Pre-Application Report

Case Number / AMANDA No. PRE-AP23-80 / 23-119180-PA
Conference Date October 23, 2023
Applicant Britany Randall
BRAND Land Use
12150 Jefferson Hwy 99E SE
Jefferson, OR 97352
britany@brandlanduse.com
Representative Lindsey King
BRAND Land Use
lindsey@brandlanduse.com
Case Manager Bryce Bishop

Project Description & Property Information	
Project Description	Conditional Use Permit for proposed expansion of an existing Room and Board Facility to serve 16 persons.
Property Address	1243 to 1245 Peace Street SE
Assessor's Map and Tax Lot Number	073W35CC03400
Property Size	Approximately 0.36 acres
Existing Use	Transitional housing facility
Comprehensive Plan Map Designation	Commercial
Zoning	CO (Commercial Office)
Overlay Zone(s) / Historic Districts	None
Urban Service Area	The subject property is located inside the City's Urban Service Area. Note: When property is located inside the City's Urban Service Area an Urban Growth Preliminary Declaration is not required for development of the property.
Urban Renewal Area(s)	None
Other Department / Agency Contacts	Building & Safety: Noelle Hall NHall@cityofsalem.net / 503-540-2406
	Fire Department: Sean Mansfield SMansfield

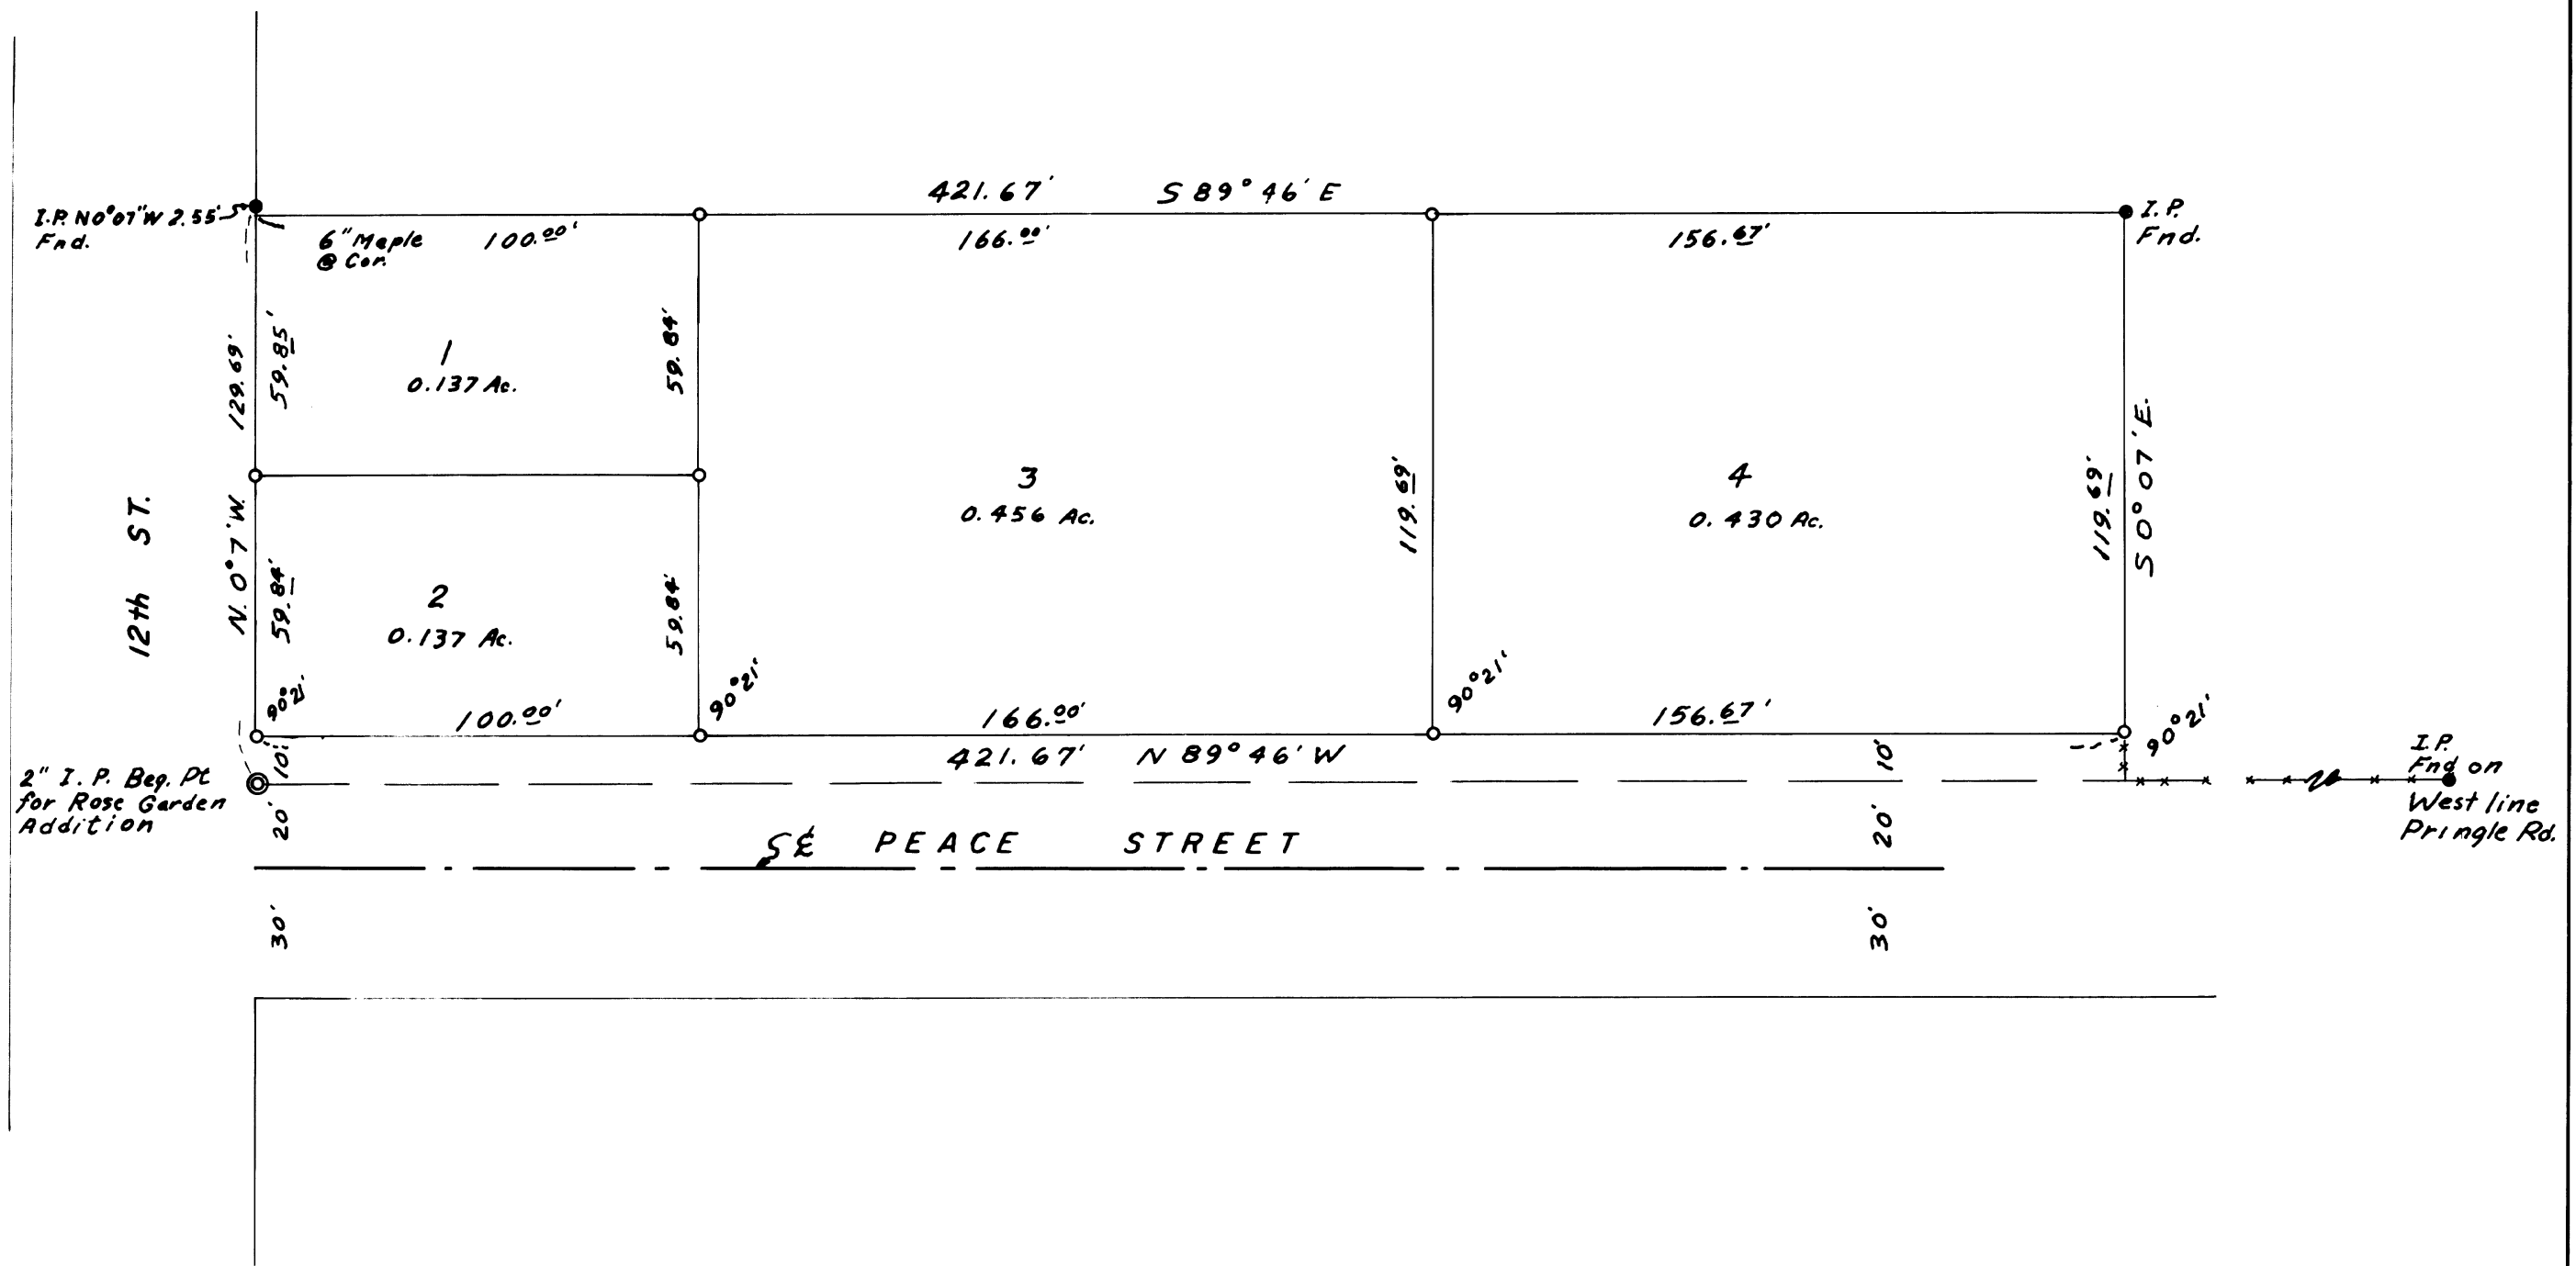
Development Site Landscaping:
-Min. 15% of development site required to be landscaped.
-Documentation will be required that a minimum of 15 percent of the development site is landscaped to the Type A standard of SRC Chapter 807.
-Landscaping Required: 15,681.6 ft.² x 0.15 = **Min. 2,352.24 ft.²**

Off-Street Parking:
-Min. Off-Street Parking: None
-Max. Off-Street Parking (Room & Board): 1 per guest room or suite

Compact Parking:
-Max. 75% of off-street spaces provided may be compact.
-Compact Spaces Provided: **100% of spaces provided are compact.**

Bike Parking:
-Min. Bike Parking (Room & Board): The greater of 4 spaces or 1 per 50 rooms
-Bike Parking Required: Min. 4 spaces (100 percent of the spaces can be long-term spaces)

Pedestrian Connections (SRC 800.065):
-Building Entrance to Street: Required (Not OK - no connection provided from building entrance to street)

SRC 807 Tree Planting Requirements:
-Trees removed from within required setbacks: Two trees with a dbh of 10 inches or greater will be removed from within the required setback abutting Peace Street. Two new trees required to be planted for each tree removed (trees must be a shade or evergreen variety with a min. caliper of 1.5 inches).
